Tivoli Mfg. Ltd.

Safety Bulletin

Bulletin No: SOSA020

Purpose: Inspection and Reinforcement of Seat Side Rails

Figure 2

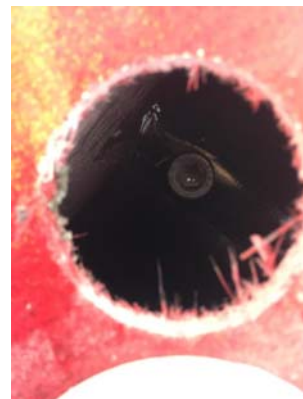
- Cut two 1 ¼" (30mm) access holes with hole saw on bottom of fiberglass seat as indicated on attached picture (see figure 1). These holes are 1 ¾" (45mm) off each side of the centerline on the seat bottom, in line with the center of the side bars.
- Drill and tap two holes (See figure 2 & 3) for an 8mm 1.25 x 25mm (grade 8.8) socket head bolt with washer.
- Install bolts with Loc tite (blue) and tighten snugly
